Thank you for your interest in the Xilinx XC3S700A FPGA device engineering samples. Although Xilinx has made every effort to ensure the highest possible quality, these devices are subject to the limitations described in this errata notification.

Table 1: XC3S700A Devices Affected by These Errata

Table 2: Hardware Errata Summary

Figure 2: DCM DFS Lock Failure Workaround

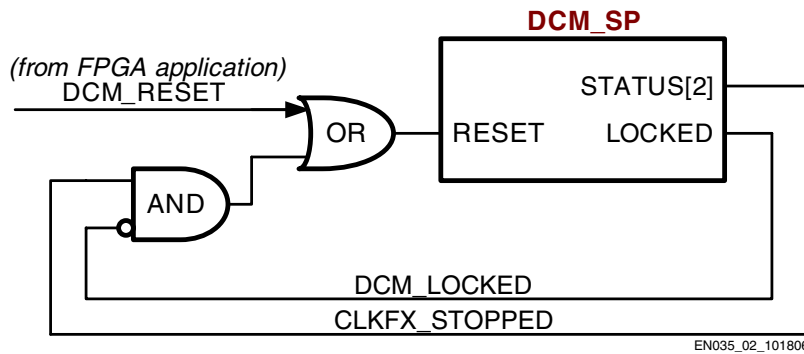
A small number of DCM DFS locking failures have been observed during characterization.

A software workaround exists, as shown in [Figure 2](#). This circuit is automatically inserted by the ISE development software starting with version 9.1i. Using FPGA logic, the circuit monitors both the LOCKED output from the DCM_SP function and the STATUS[2] bit, which indicates that the DFS output CLKFX has stopped. If LOCKED = 0 and STATUS[2] = 1, then the circuit asserts the DCM RESET input. If the FPGA application also resets the DCM, then OR the reset signal from the FPGA application with the monitored output signals.
